To: T10 Technical Committee
 From: Bob Sheffield (robert.l.sheffield@intel.com)
 Date: 30 May 2006
 Subject: 06-262r0: SAT - Example Configurations

Discussion of letter ballot comments in subclause 5.1, the Architecture Overview, led to direction to copy and modify figures from the VPD pages showing basic usage models for SAT into the Architecture Overview showing the three examples listed. This proposal shows the suggested changes, and is intended to resolve letter ballot comments in subclause 5.1 related to the example implementations.

Figure 5 — SATL contained within a SCSI target device

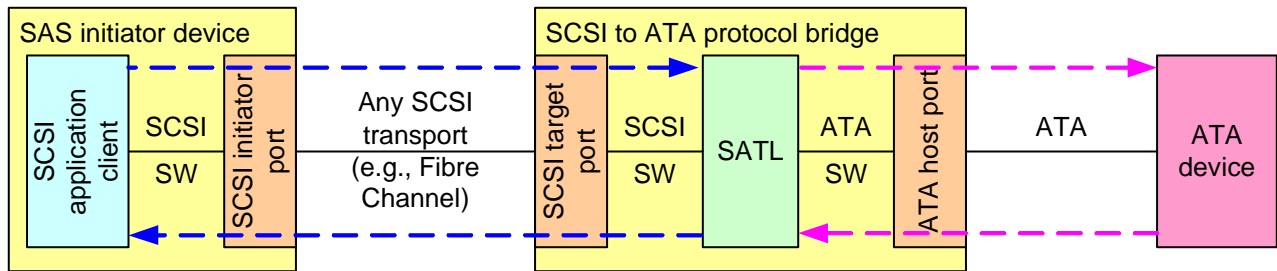
EXAMPLE 1 - Figure 5 shows a SATL contained within a SCSI target comprised of ATA device(s) using a defined SCSI transport (e.g., Fibre Channel, SCSI parallel interface, or SBP-3).

Figure 6 — ATA HBA directly connected to ATA devices and/or ATAPI devices

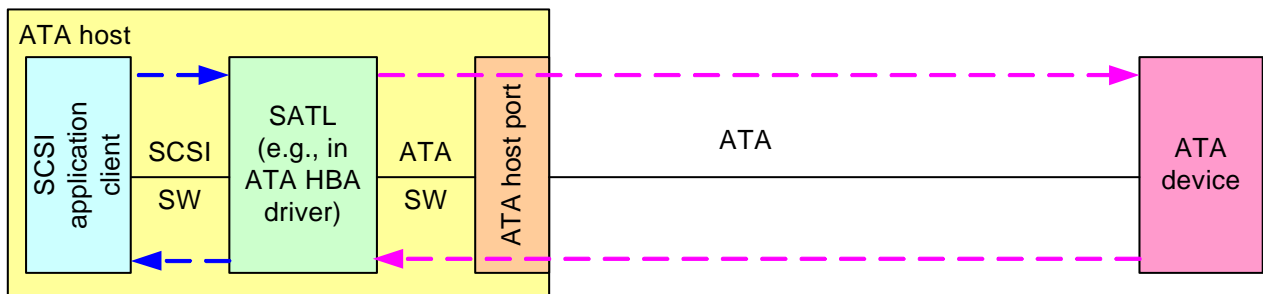
EXAMPLE 2 - Figure 6 shows an ATA/ATAPI Host Bus Adapter (HBA) directly connected to ATA device(s) and providing SCSI transport protocol layer services to a SCSI application client in accordance with SAM-3.

Figure 7 — SAS STP initiator port connected to ATA devices and/or ATAPI devices

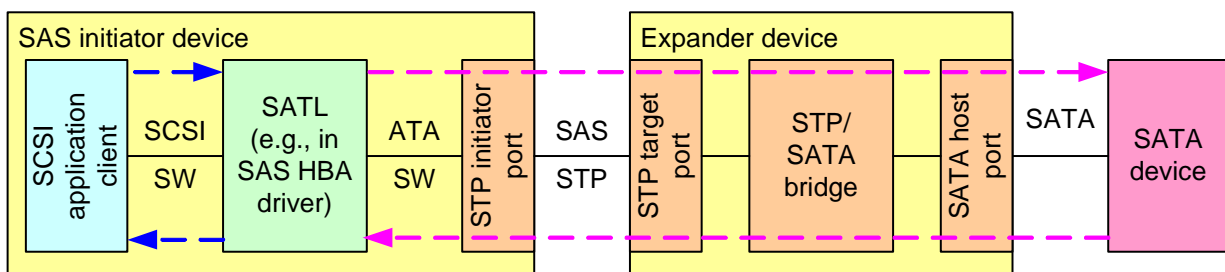
EXAMPLE 3 - Figure 7 shows a SAS STP initiator port (see SAS-1.1) connecting to ATA device(s). The STP initiator port includes a SATL to provide the SCSI transport protocol layer services to the application client.
